23 Maple Street Historic Exterior Restoration

#### ADDENDUM NO. 1

# 23 MAPLE STREET HISTORIC EXTERIOR RESTORATION Arlington, Massachusetts

#### Drawing A1

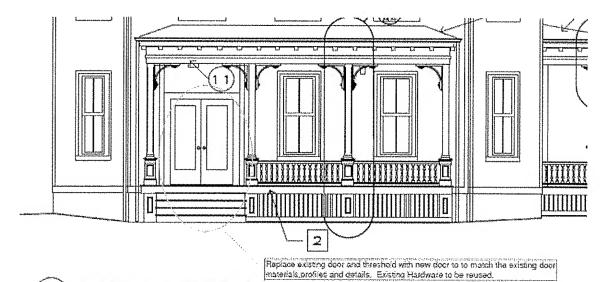
Demolitions and Preparation Notes: Delete note #13. Change note #17 to read "Existing door and threshold to be removed, prep and prepare for replacement door to match existing.

- 1. Existing South Elevation: Delete note 13 and insert note #17 in its place.
- 2. Existing North Elevation.
- 3. Refer to drawing below.

Drawing A3 Elevations

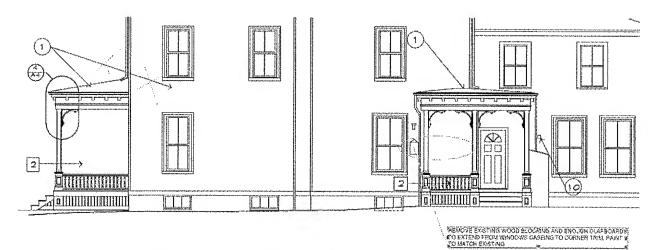
Refer to revised scope of work below.

#### Drawing A4 Details

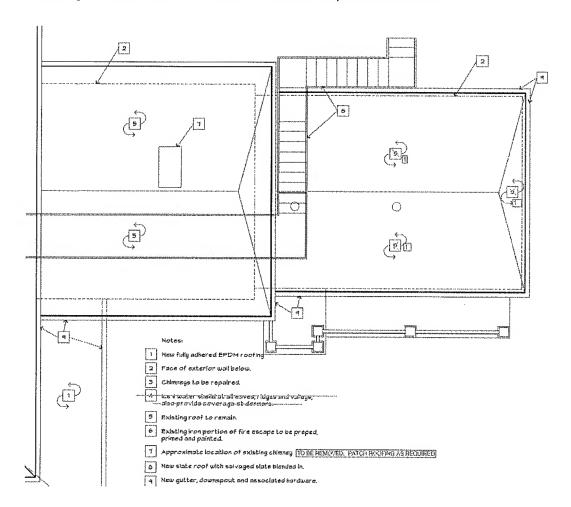
1. Detail 5: Note pointing to gutter. Change note to read "aluminum gutter and downspouts". There are no wood gutters.
